Value Engineering Study

East Side Coastal Resiliency Project

April 2018

Preliminary
Value Engineering Study Report
for

Detail taken from USACE HSDRRS

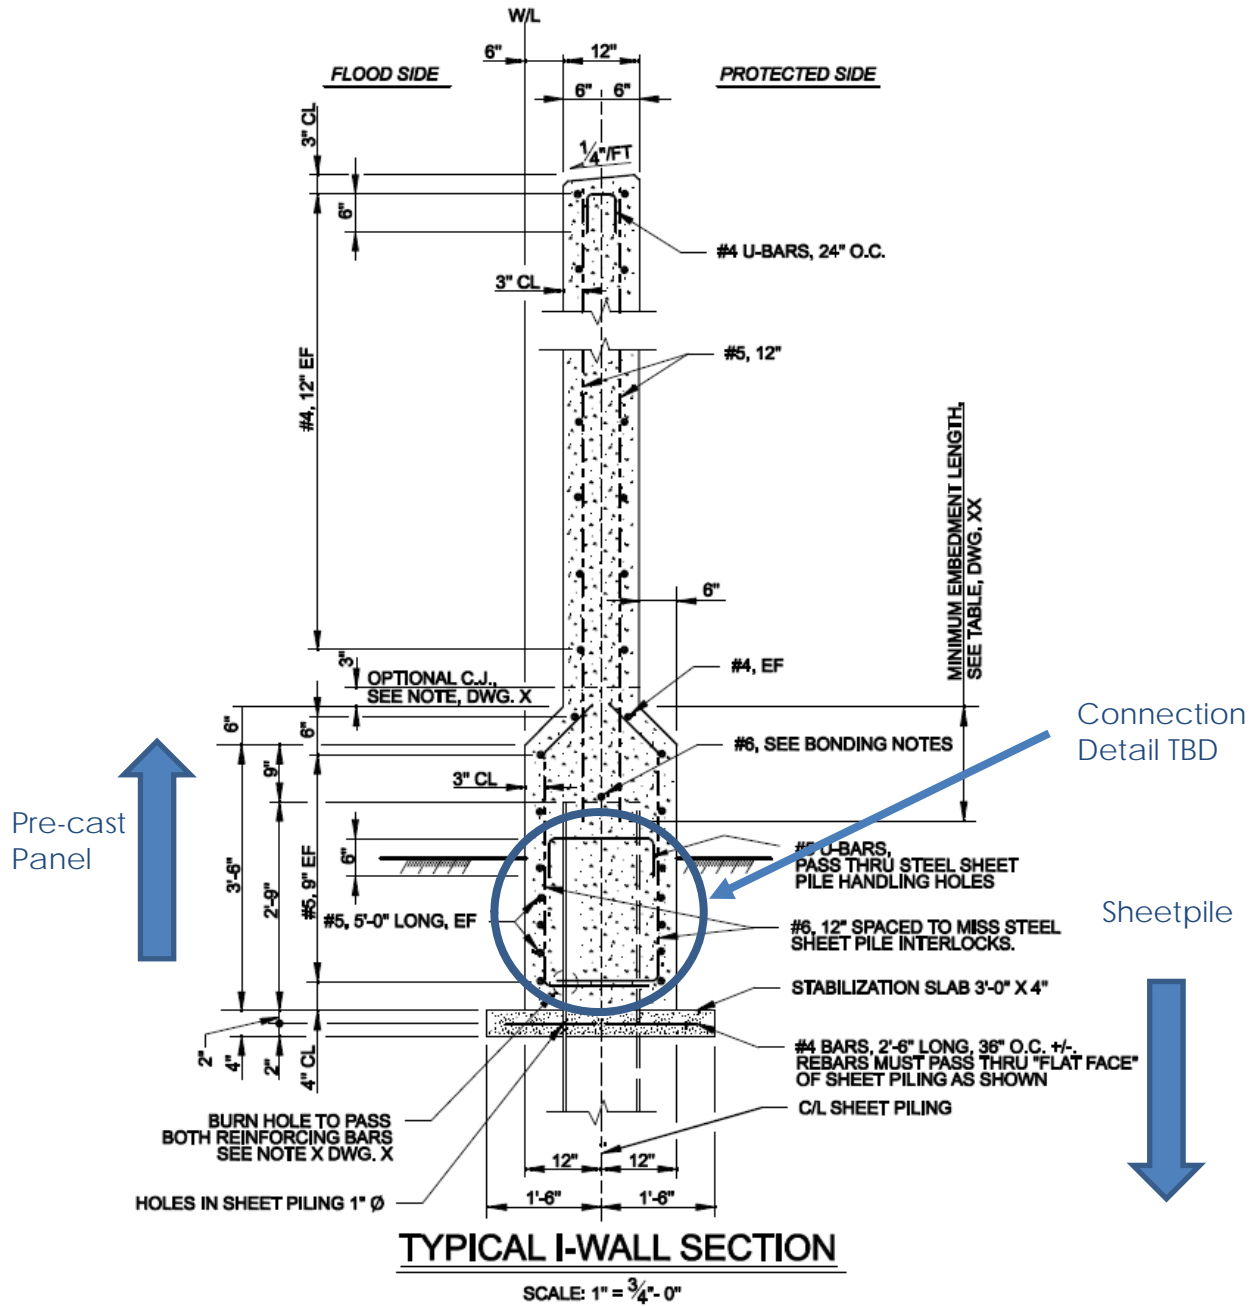
Capping the sheet pile wall by casting concrete in place to form an I-wall section is the original concept and a customary practice (see original sketch following). This alternative includes the design and construction of a pre-cast cap section that could be placed over the sheet pile cut-off and grouted in-place.

The typical detail from The U.S. Army Corps of Engineers Hurricane and Storm Risk Reduction System (HSDRRS) guidance is included in the sketch. In the typical section, holes are cut in the sheet pile to allow rebar to pass through the sheet pile at the top and bottom of the connection for the cast in place method. So "just" dropping a precast segment over the pile and grouting would not be sufficient. Some creative details for the joint would need to be developed. Aligning holes in precast and sheet pile could be an issue. And may require field drilling the sheet pile holes. The length of cap and vertical joint details will need to be designed as well.

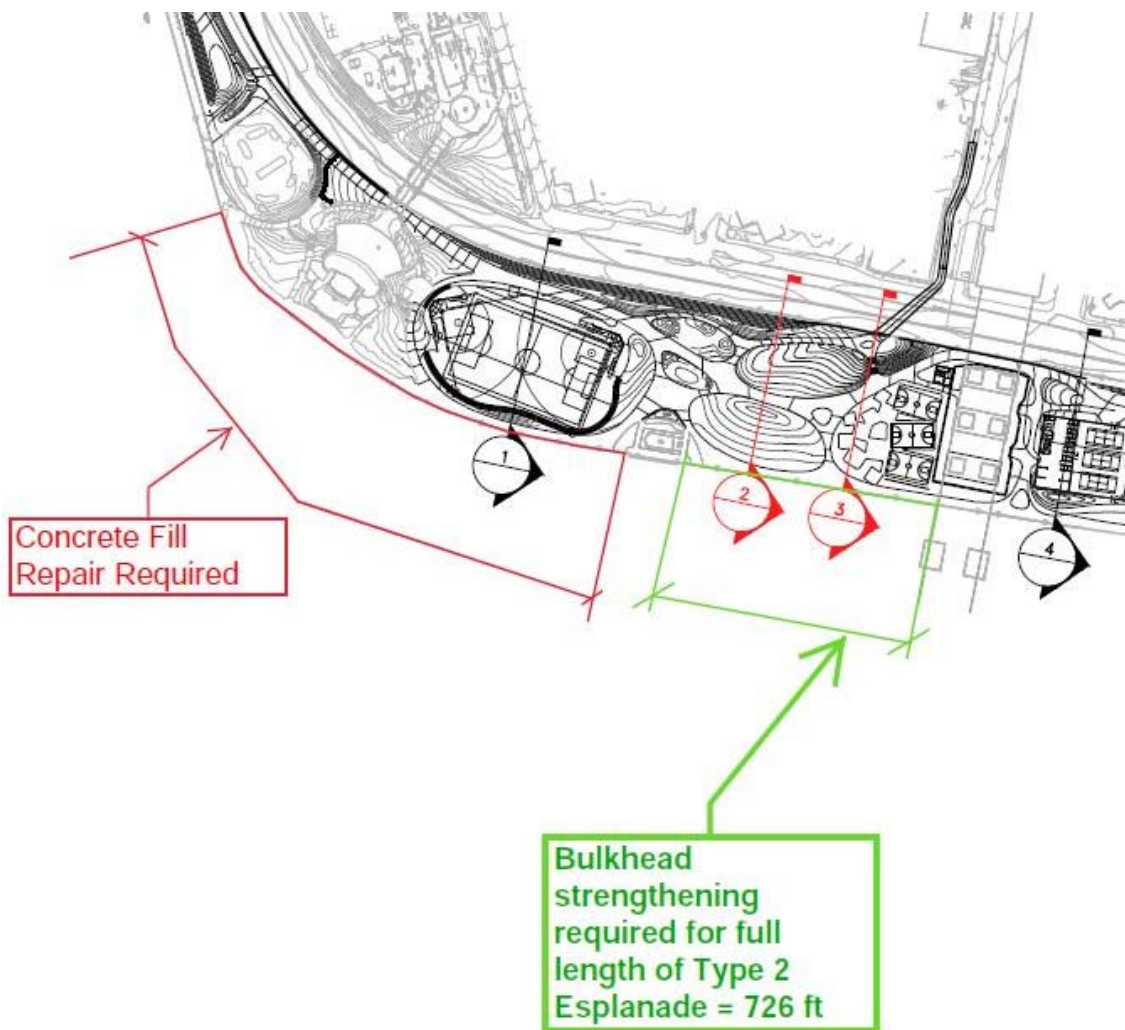
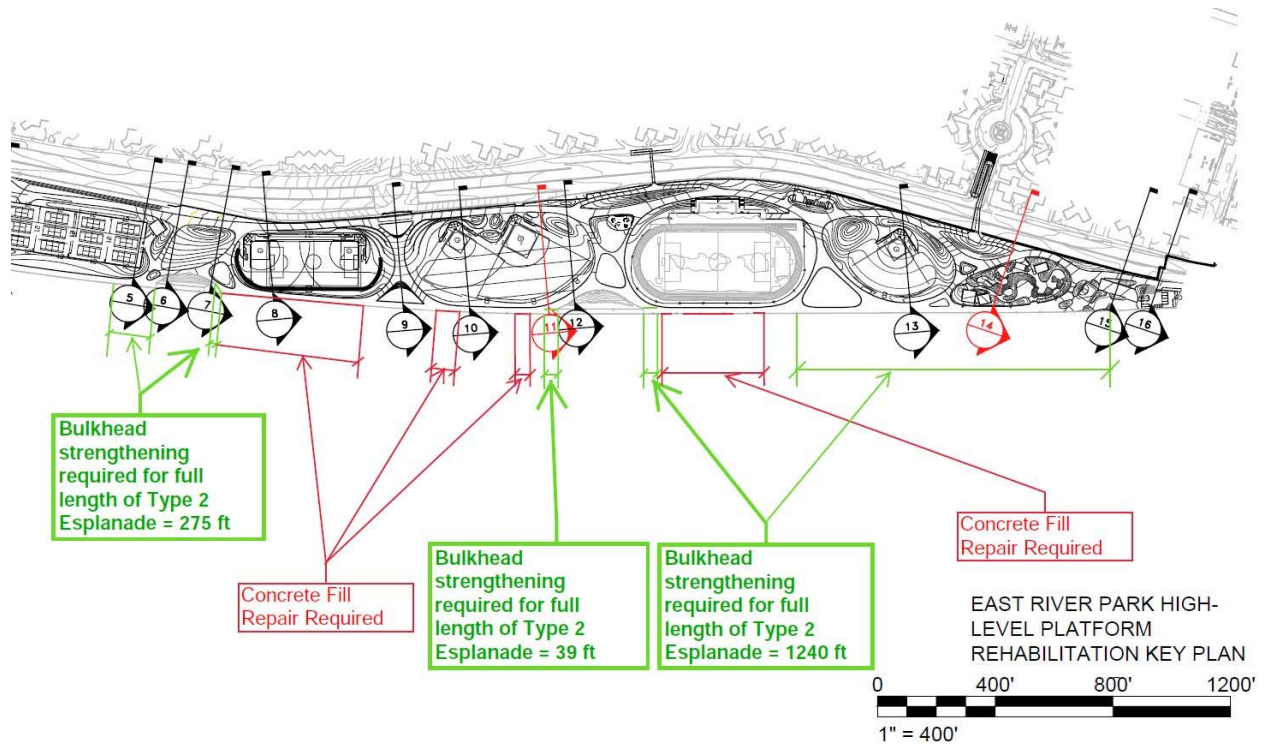
The priority repairs which were recommended in the Sept. 29, 2016 bulkhead inspection report extend along most of the length of the esplanade. The nature of the repairs indicate that they are necessary to safely support heavy loads and to prevent future settlement inland of the recently completed high-level relieving platform construction.

It is recommended that this work be expedited to allow contractors' unimpeded use of the esplanade, subject to specified park use restrictions and marine accessibility considerations and included as part of this project to access HUD funding.

Sketch shows Reach H and Half of I

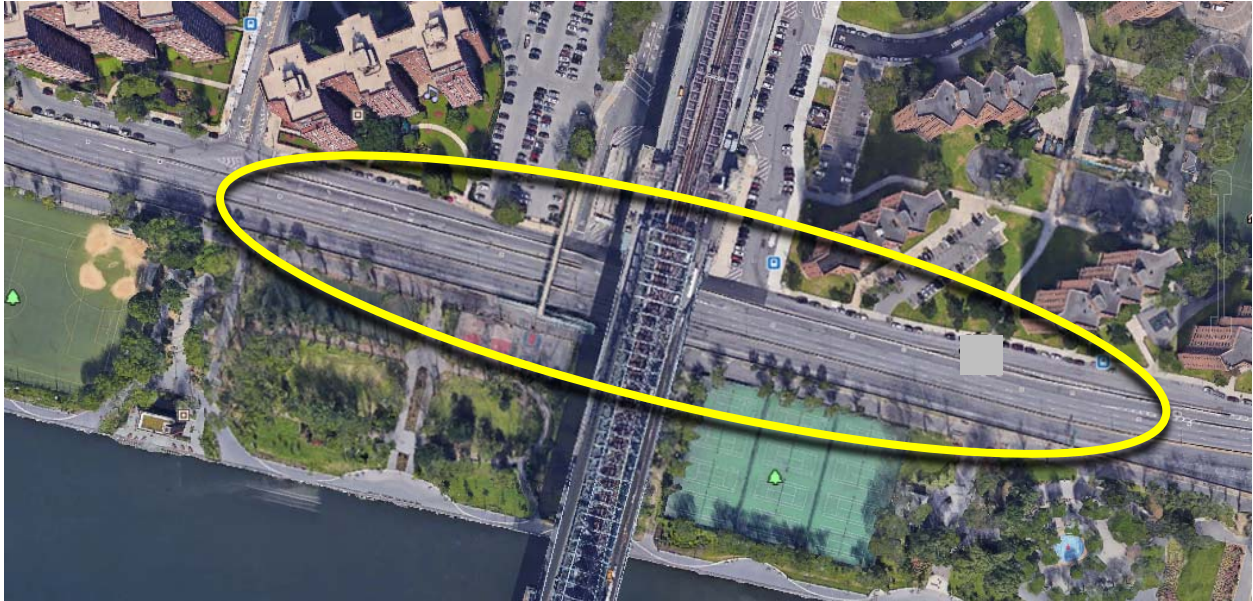
- Area of lane shift transition to service road.
- Make lane adjacent to wall available for construction.

Alternative No.: C-51

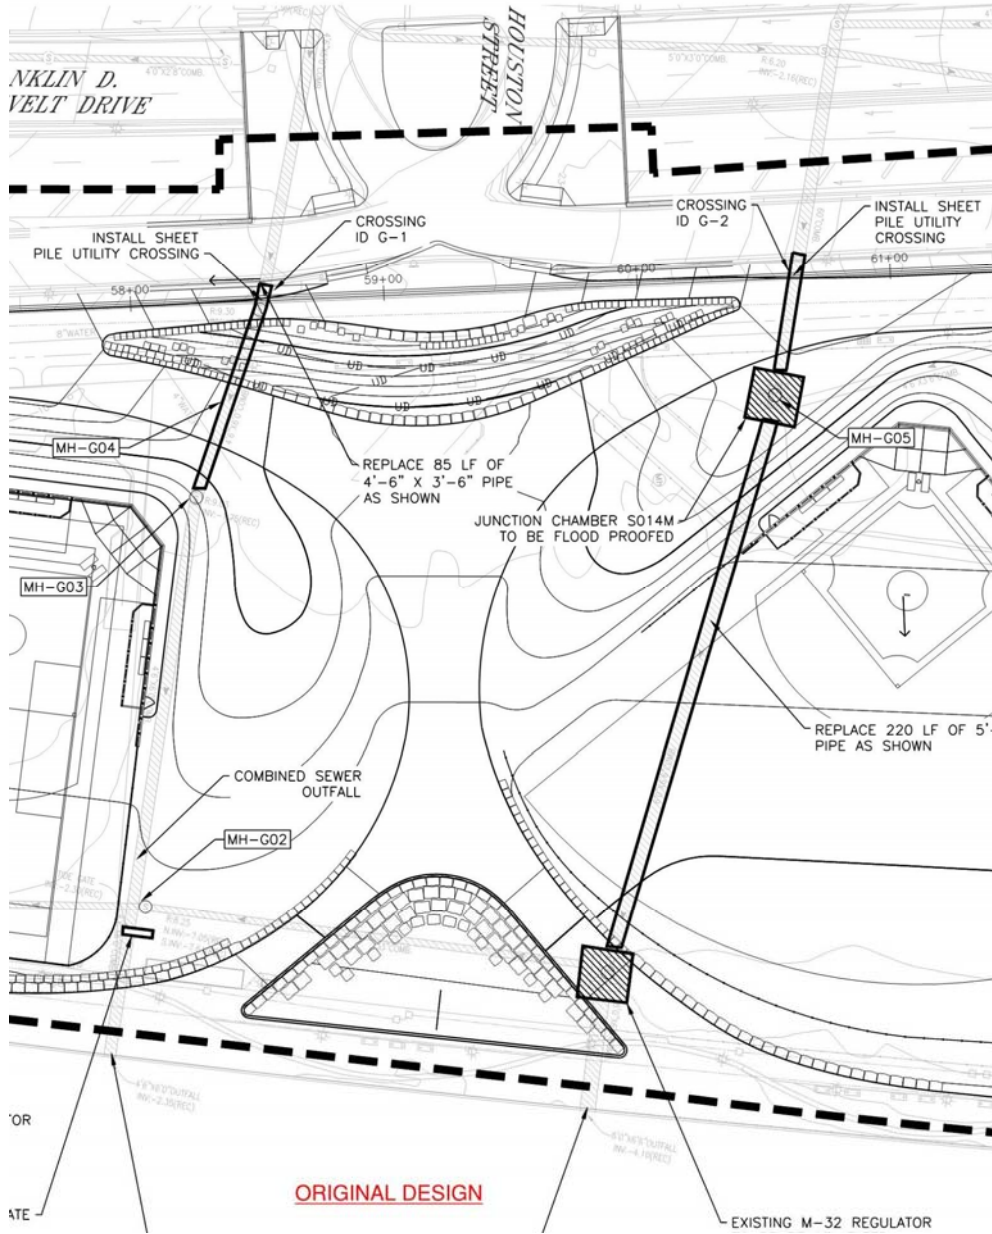
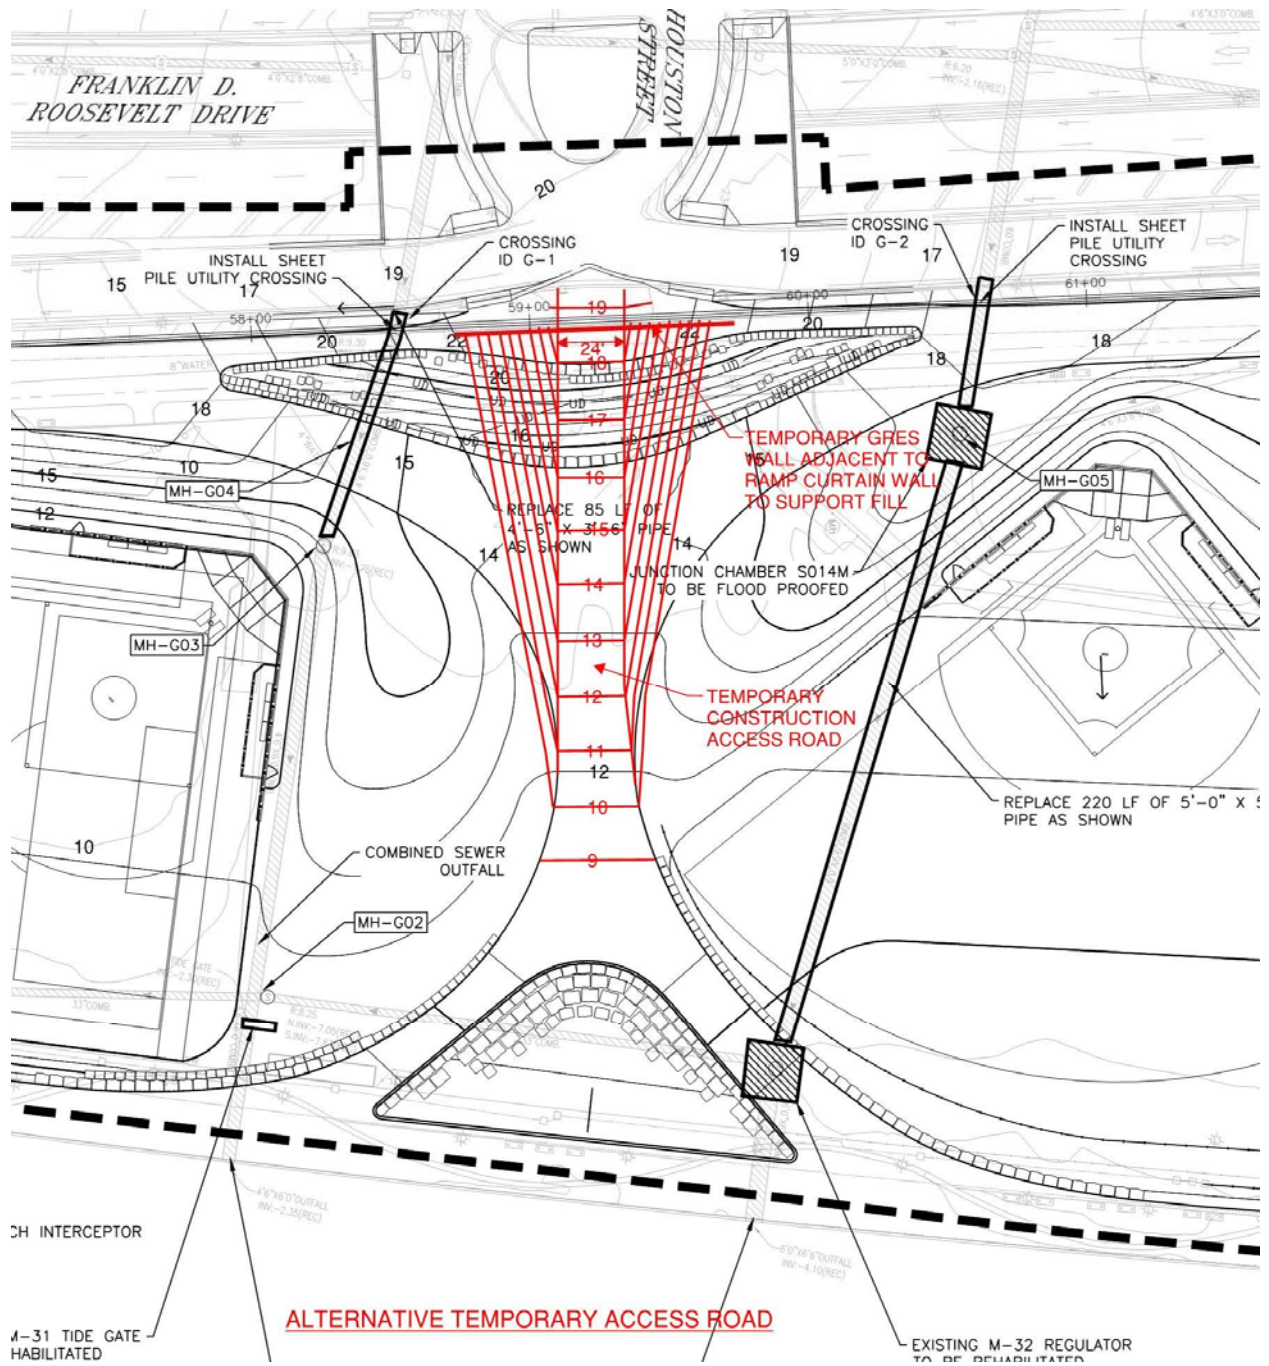
Providing a second access point to the park will likely increase productivity and shorten overall construction duration, as well as improve site safety. Congestion from construction vehicles at the only current entrance at Montgomery Street will be alleviated.

Installation of the temporary access ramp on fill will require the installation of a reinforced earth (GRES type) retaining wall parallel to the Houston Street ramps and overpass curtain wall in order to avoid loading of these facilities. The existing pedestrian ramp from the overpass needs to be supported to accommodate loading from construction vehicles. Temporary fill will not have to be removed, since the area is being built up in final condition.

Alternative No.: IA-03

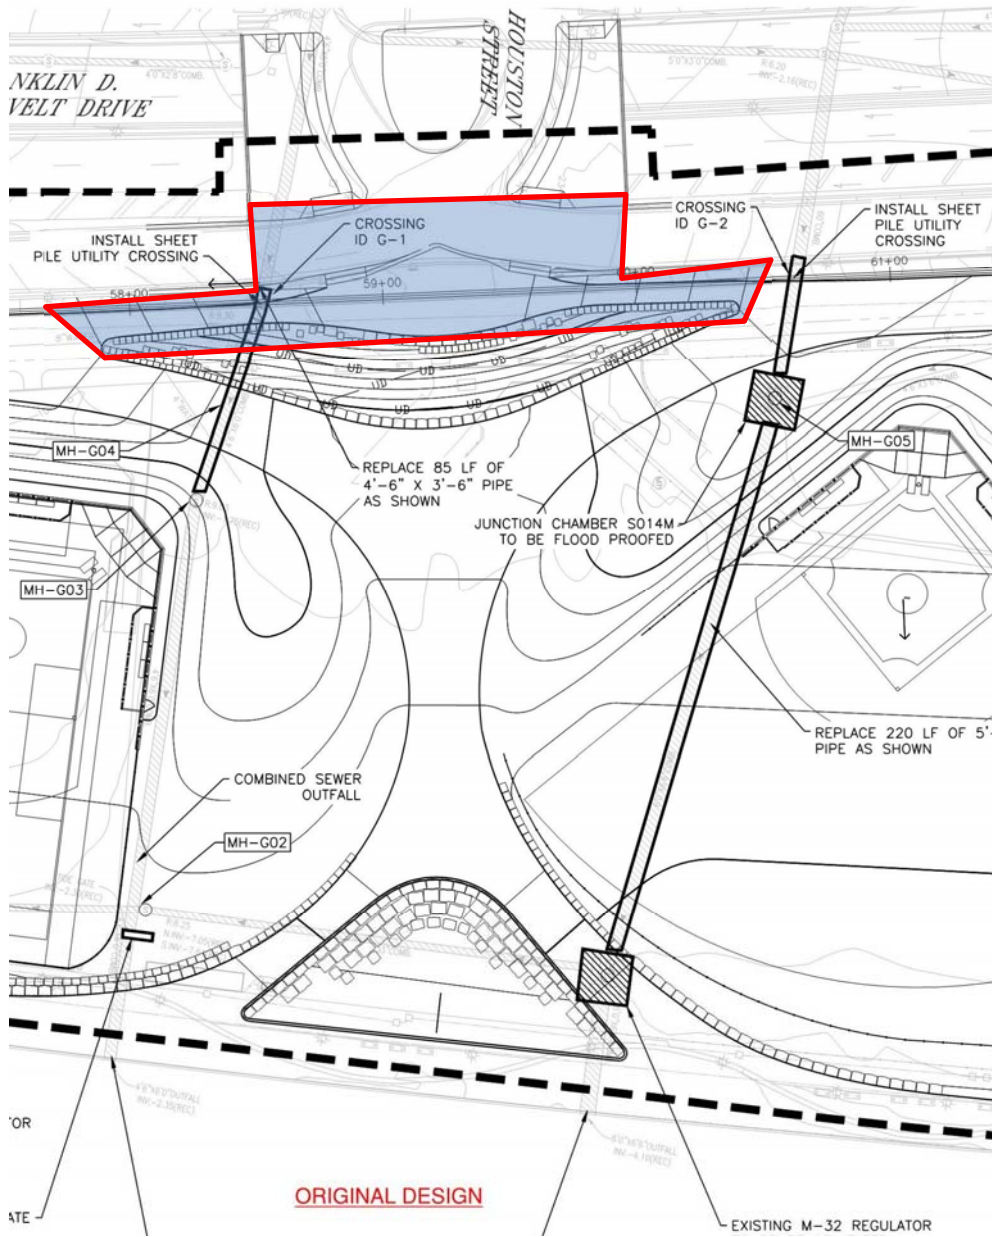
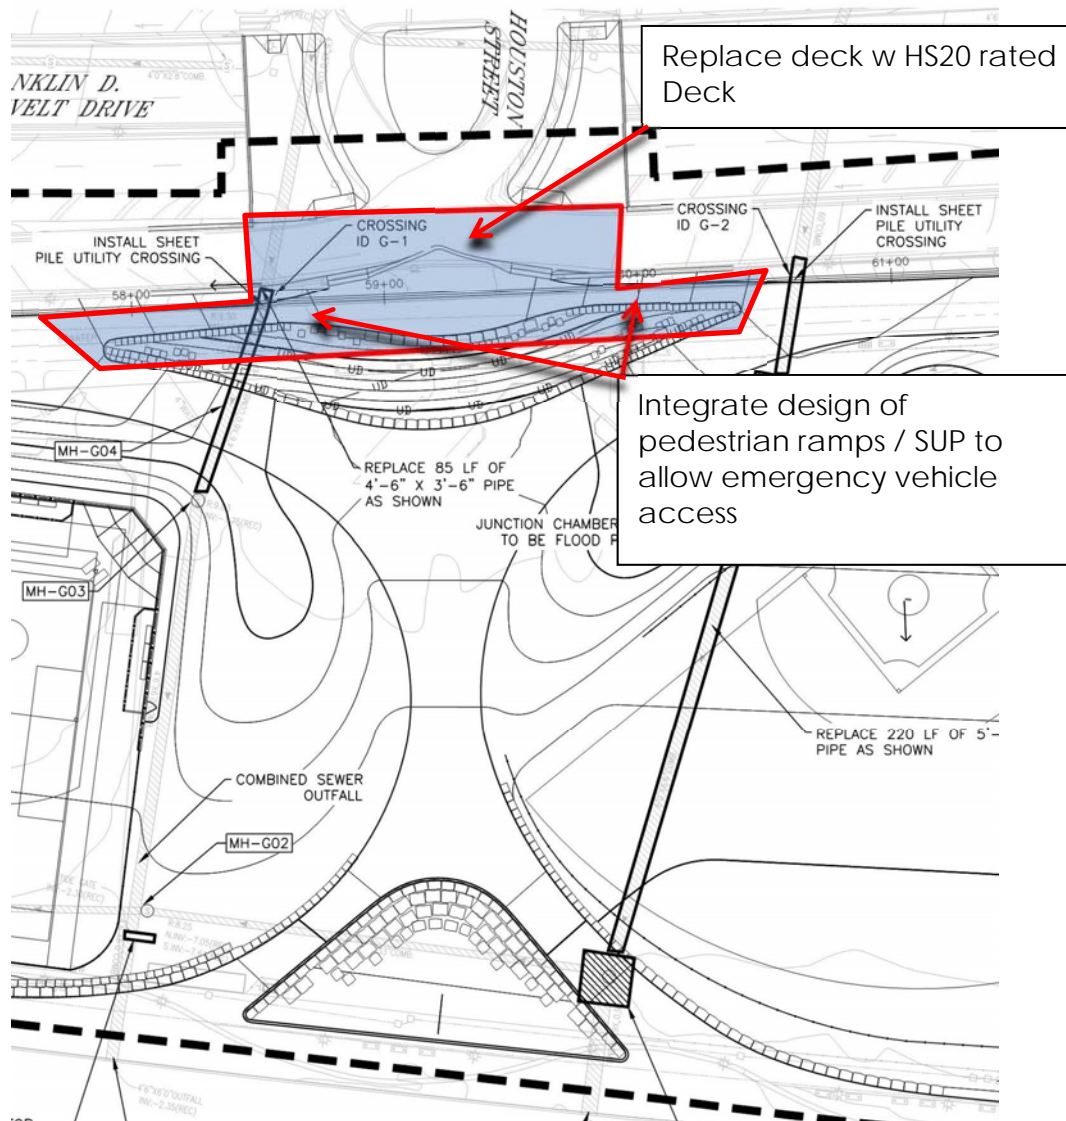
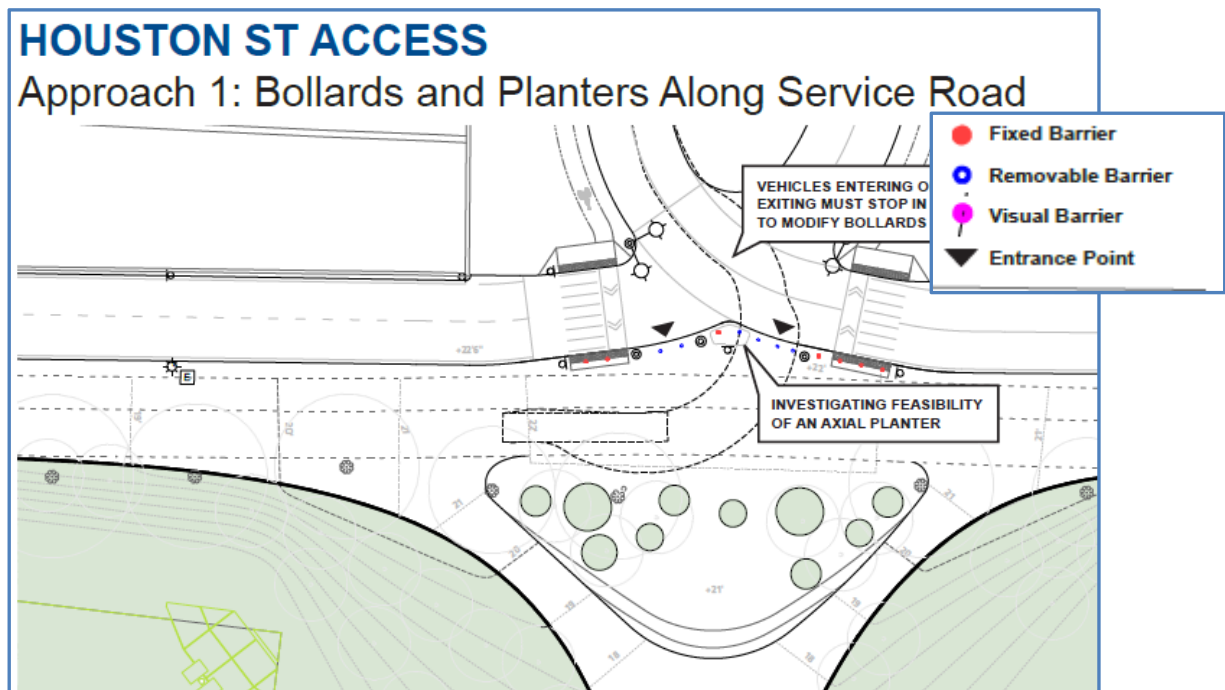
Existing portion of the Houston Street deck is not HS20 rated.

Rebuild Houston Street Deck and pedestrian ramps to handle HS20 loads. Integrate Pedestrian Ramps to accommodate fire trucks and emergency vehicles.
